PLANS AND DOCUMENTS  
referred to in the PDA  
DEVELOPMENT APPROVAL

Approval no: DEV2020/1124  
Date: 22 December 2021

Date: 16 November 2020

Subject: 12-18 Thompson Street Material Change Use under PDA Development Permit  
Acoustic Aspects

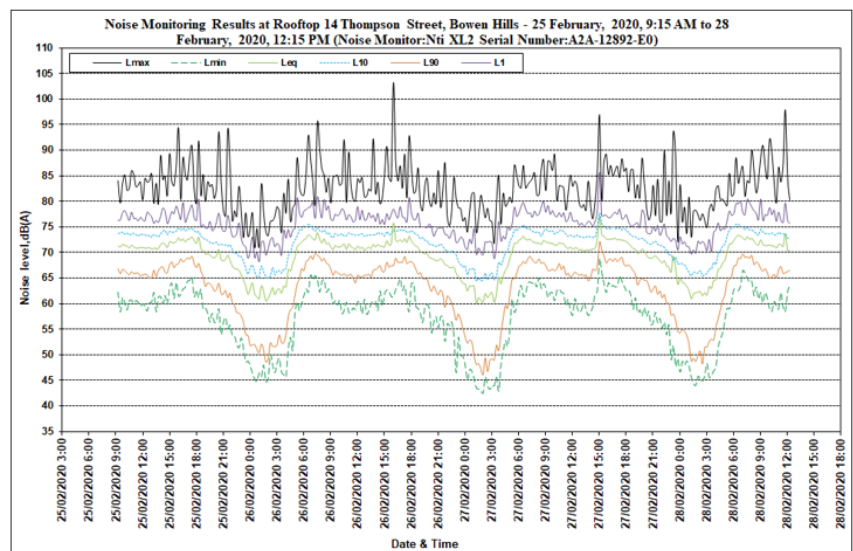
TMR response required	Stantec response
<p><b>Submit a revised Noise report that addresses the following</b></p>	
<p>1.a</p> <p>The revised report must be based on architectural drawings of an adequate level of detail for proposed Towers 1-4. These should show the layout of the noise sensitive uses (childcare centre, health care services and hospital uses) on the site, including the internal floor plan of the buildings and intended finished levels. The plans on which the report is based should be included as an attachment in the report.</p>	<p>The site is affected by two aspects of transportation noise:</p> <ol style="list-style-type: none"> <li>1. Road traffic noise from the inner-city bypass (ICB); and</li> <li>2. Railway corridor noise, 55m from the site and shielded by the elevated road structure of the ICB.</li> </ol> <p>The ICB is under the control of Council and TMR have no responsibility for the assessment of noise emissions from this road. It is understood that EDQ have not made any request within the RFI with respect to transportation noise.</p> <p>It is further understood that the request from TMR relates only to railway noise. As noted above the railway is located a minimum 55m away and is largely shielded by the elevated ICB road structure.</p> <p>Detailed architectural drawings for Tower 2-4 are not available at this stage. Tower 1 is greater than 100m from the railway. The location of the uses within Tower 1 (i.e. the internal floor plan with finished levels) have not been defined. The same applies for Tower 2-4 which are currently at Masterplan stage.</p> <p>Thus, the intent of the acoustic report was to demonstrate feasibility of Tower 1 and the overall Masterplan by providing recommendations for the future layout of uses to protect these against dominate road traffic noise from the Inner-city Bypass (ICB).</p> <p>Section 6.3 of the acoustic report states:</p> <p><i>Analysis of the noise data showed that acoustic treatment will be required to be applied to Building 2-4 facades, where healthcare uses are introduced facing the ICB. Road traffic noise intrusion from the ICB of up to 32 dBA will be required.</i></p> <p><i>Alternative options to manage the noise levels include:</i></p> <ul style="list-style-type: none"> <li>• Placement of health care uses facing away from the ICB;</li> <li>• High performance façade glazing systems;</li> <li>• corridors around the perimeter of health areas to achieve noise limits inside patient care and other areas using glazing systems with a lower acoustic performance.</li> </ul> <p>Note the 32dBA road traffic noise attenuation was determined from the noise monitoring conducted at 10m from the closest ICB lane, as shown below.</p>

In addition to the Medical uses, the application included a childcare centre use which has been removed from the development application since the issue of the acoustic report.
